**DEVIATION REQUEST  
AND DECISION FORM**

Project Name :	<b>Retreat at PrairieRidge Filings 1-3 Preliminary Plan</b>
Schedule No.(s) :	52280-00-024 & 52280-00-025
Legal Description :	See attached

A deviation from the standards of the ECM in **Chapter 2.2.5.E** is requested.

RETREAT AT PRAIRIERIDGE FILINGS 1-3			
PRELIMINARY PLAN			
FILING 1 & 2			
DESIGNED BY	MAW	SCALE	DATE
DRAWN BY	MAW	(H) 1" = 60'	SHEET 6 OF 28
CHECKED BY	(V) 1" = N/A	JOB NO.	1305.10

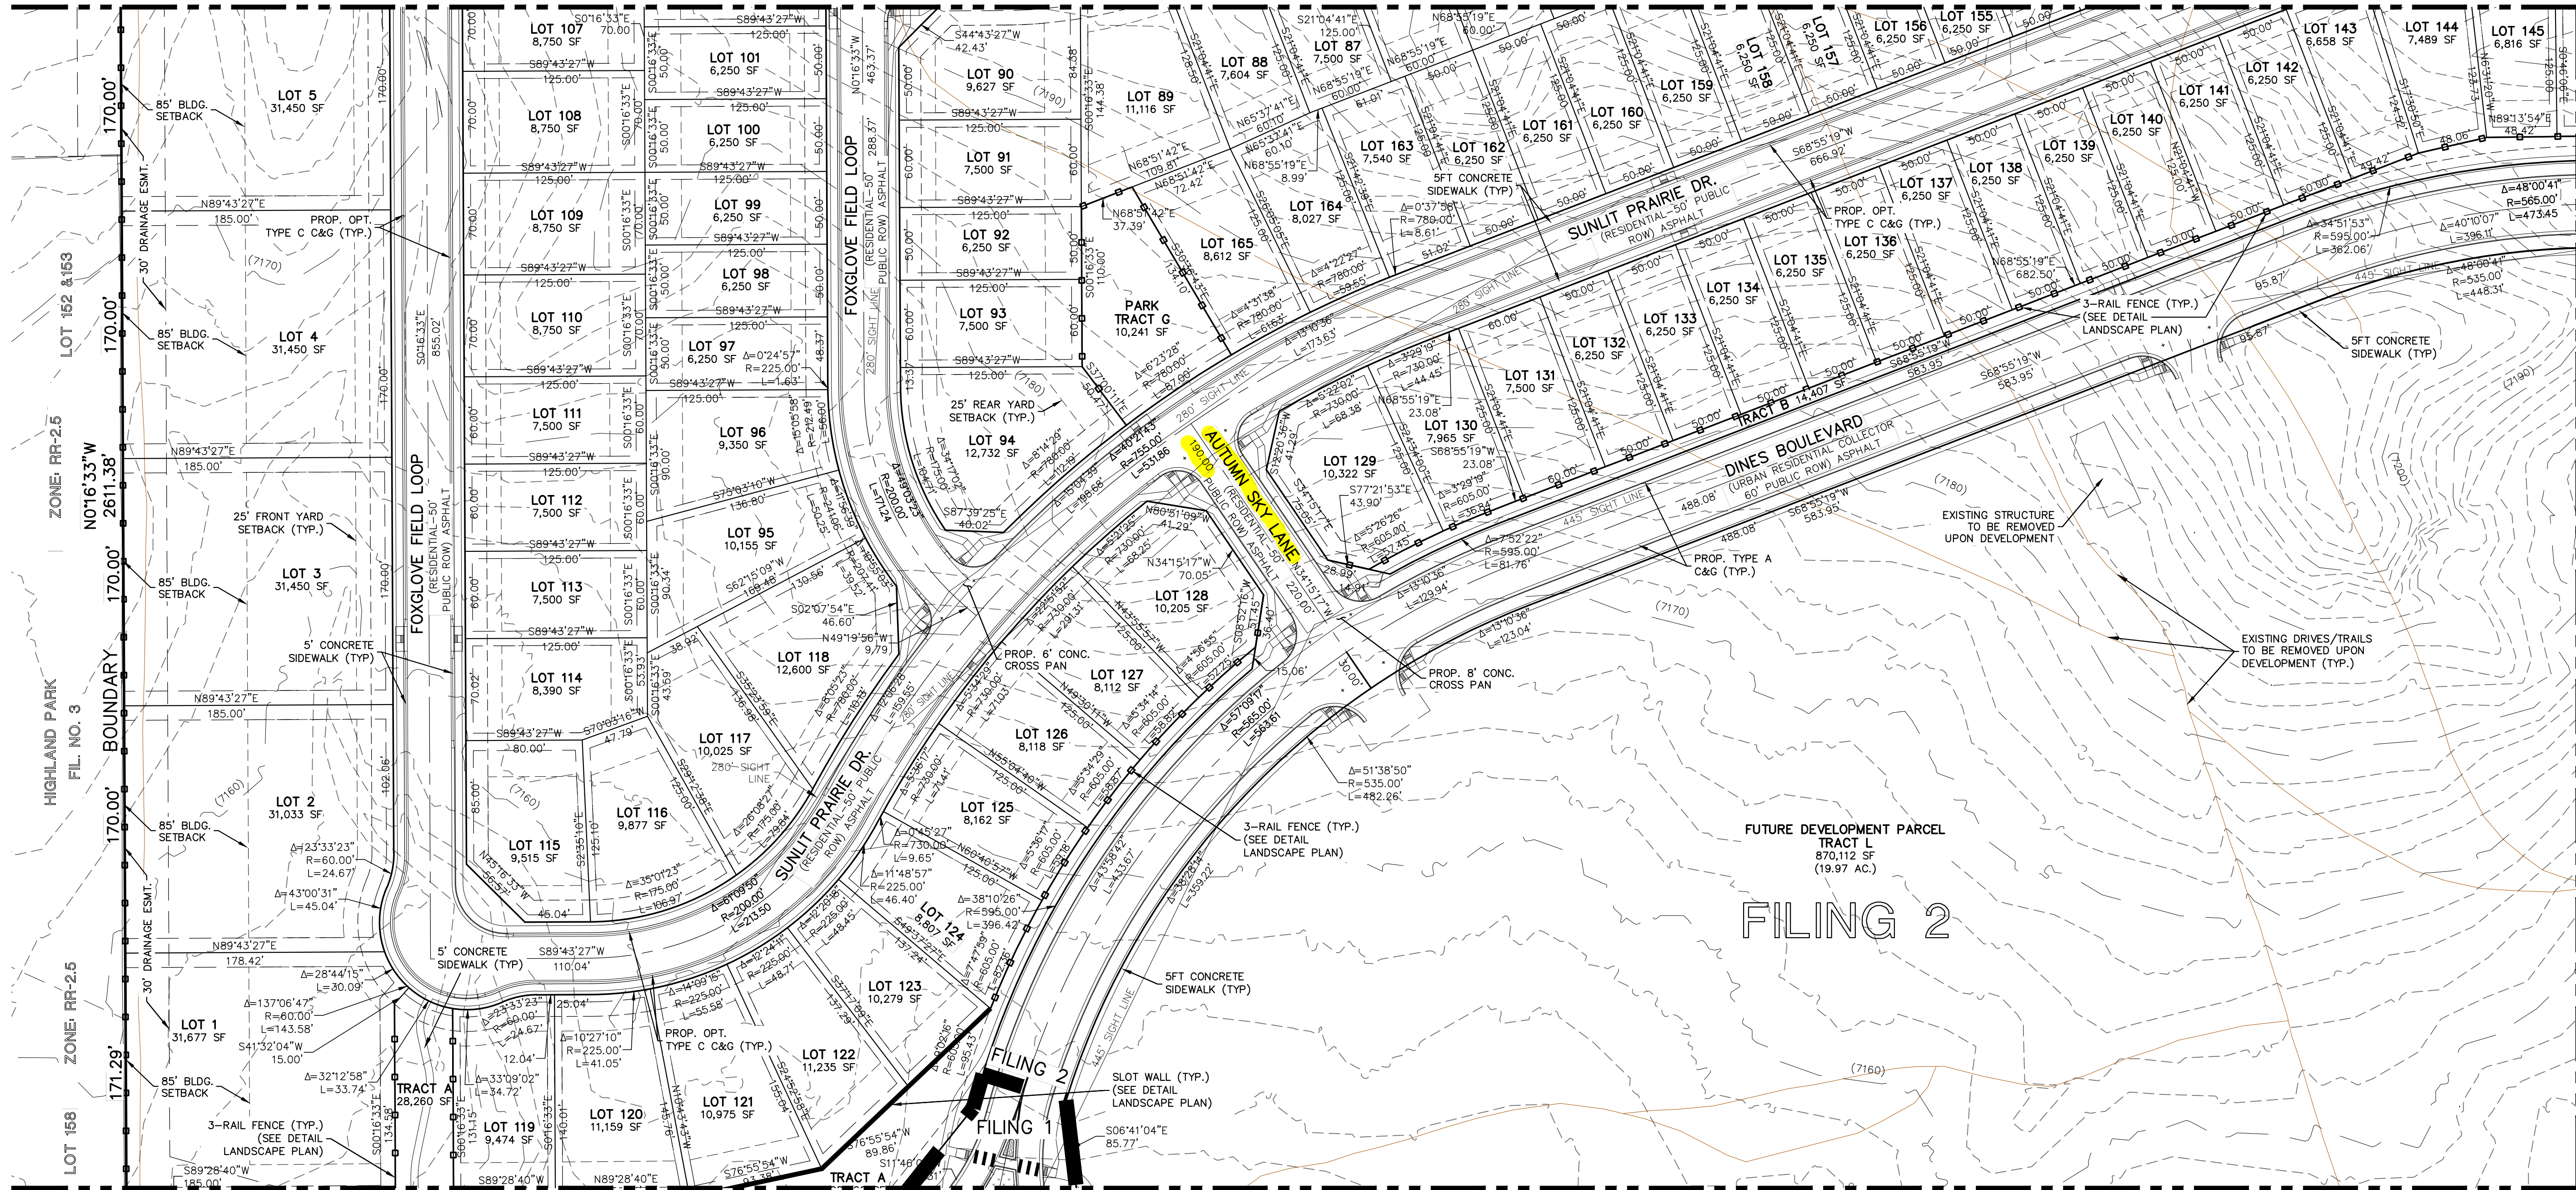
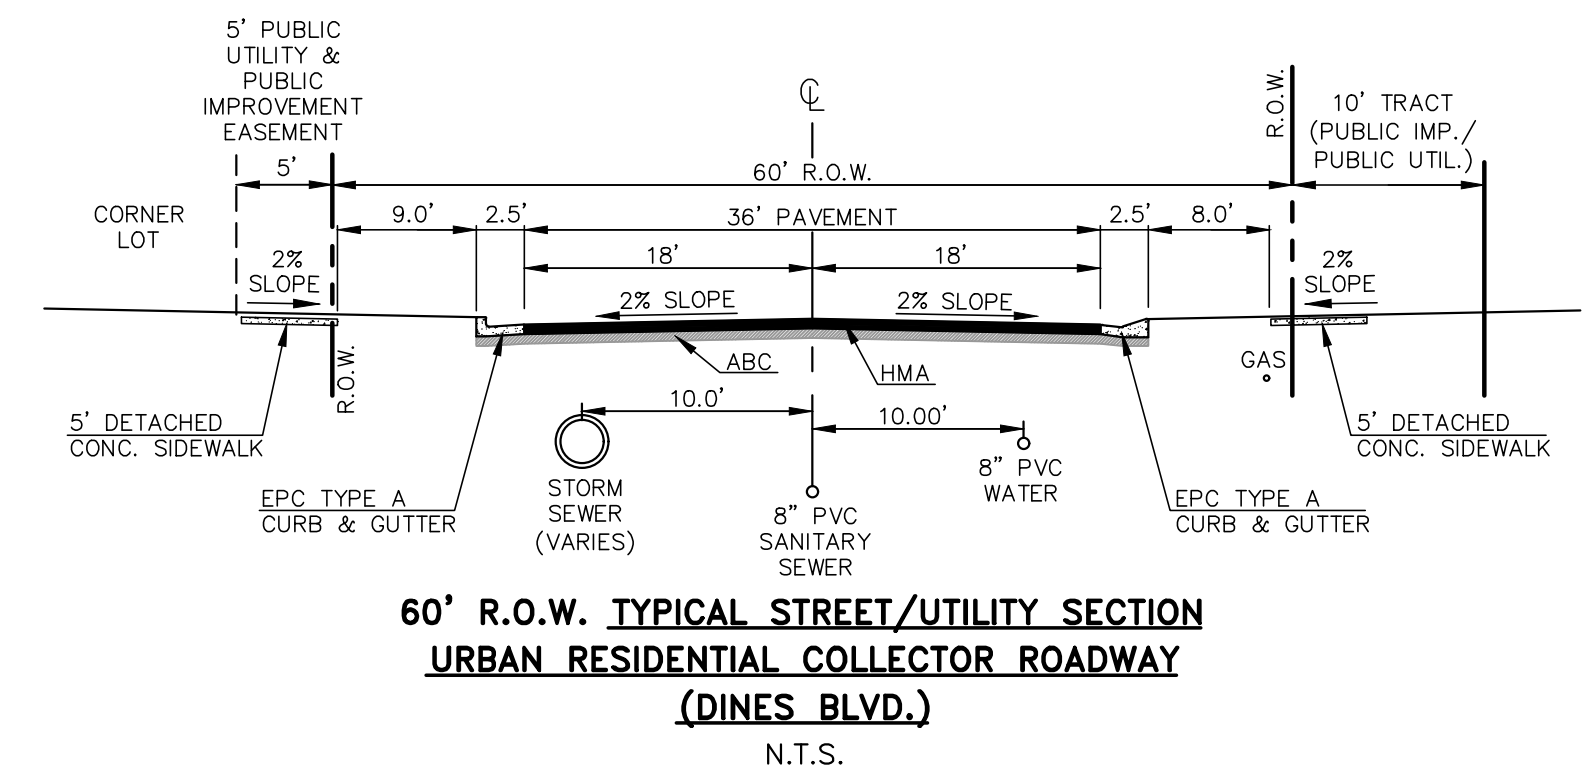
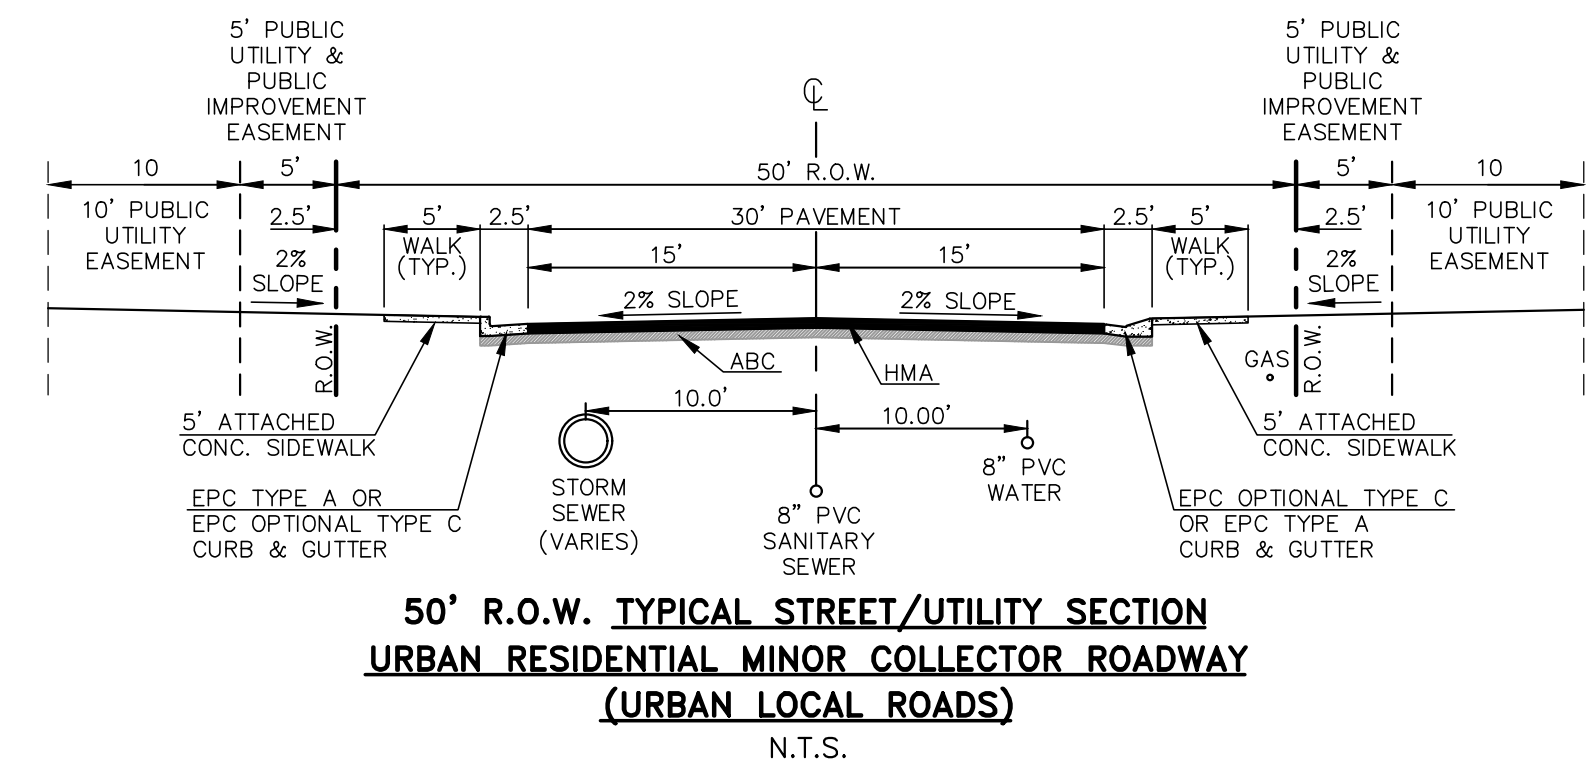
An urban local intersection is planned 190' away from collector road (CL to CL) rather than the required 200'. This design is based on a standard single family lot depth of 125' along with a 10' tract adjacent to the collector road. (Reference the Preliminary Plan – Autumn Sky Lane connection between Dines Blvd. and Sunlit Prairie Dr.)

The proposed alternative is to maintain a reasonable lot depth of 125' along with a 10' open space tract adjacent to the collector roadway as required for double frontage lots. This CL-CL distance between intersections then equals 190' rather than the 200' criteria.

In urban single family developments it is standard practice to have typical lot depths or 100'-120'. In this portion of the project, the lots are double frontage lots and an additional open space tract (10' in this case) is planned adjacent to the collector roadway. Thus, the 125' lot depth and 10' tract determined the 190' CL-CL spacing. (Reference the Preliminary Plan – Autumn Sky Lane connection between Dines Blvd. and Sunlit Prairie Dr.)

Explain how it won't affect safety or operations.

Provide more explanation of how maintenance won't be affected.

Expand on this. How are the aesthetics not affected?

State how the design still meets intent and purpose of the standards.

RETREAT AT PRAIRIERIDGE FILINGS 1-3  
PRELIMINARY PLAN  
FILING 1

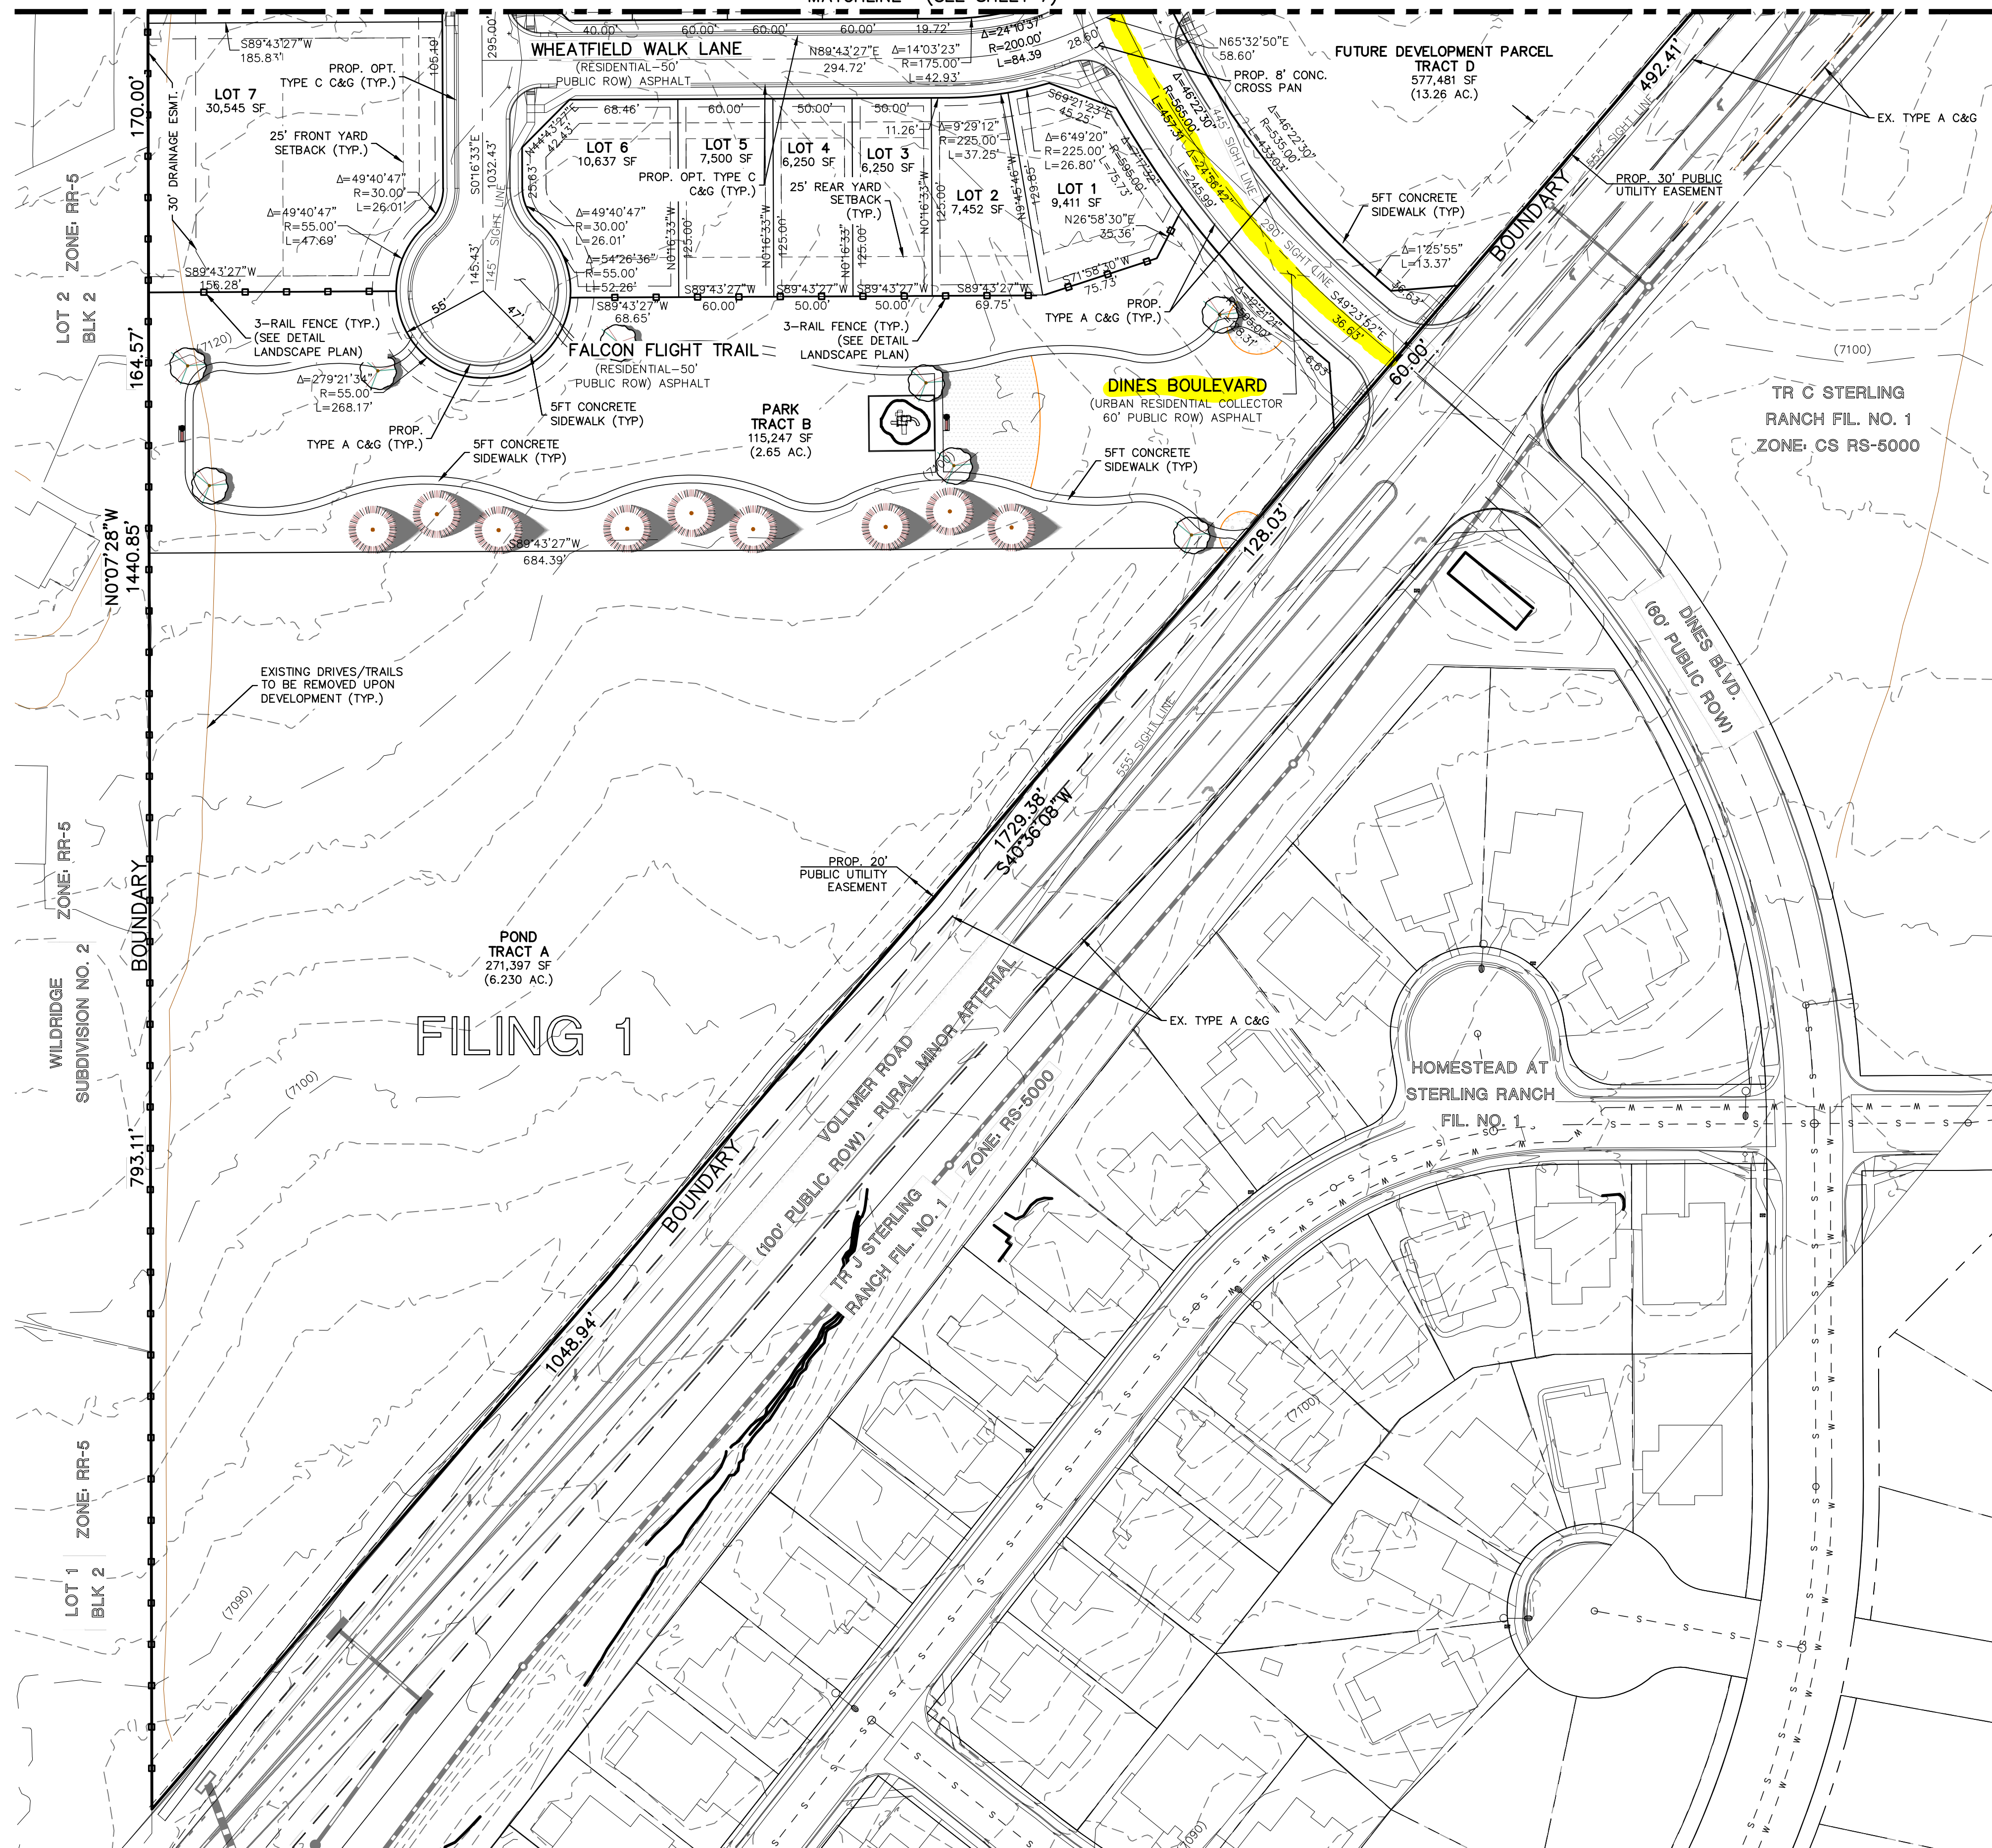
An urban local intersection is planned 282' away from a rural arterial (ROW to CL) rather than the required 330'. This design again is based on a standard single family lot depth of 125' along with a park tract adjacent to the arterial road. (Reference the Preliminary Plan – Dines Blvd. connection between Wheatfield Walk Lane and Vollmer Road)

The proposed alternative is again to maintain a reasonable lot depth of 125' along with a park tract between the lots and Vollmer Road as required by the 50' buffer and park as shown on the approved Jaynes Property Sketch Plan (SKP225) This ROW-CL distance between intersections then equals approximately 282' rather than the 330' criteria. Incidentally, the CL-CL distance equals 332'.

The southern portion of the project has a similar condition, however, there is a park planned between the lots and Vollmer Road. The 125' lot depths and the varying width of the park in this area determine the 282' ROW-CL spacing. (Reference the Preliminary Plan – Dines Blvd. connection between Wheatfield Walk Lane and Vollmer Road)
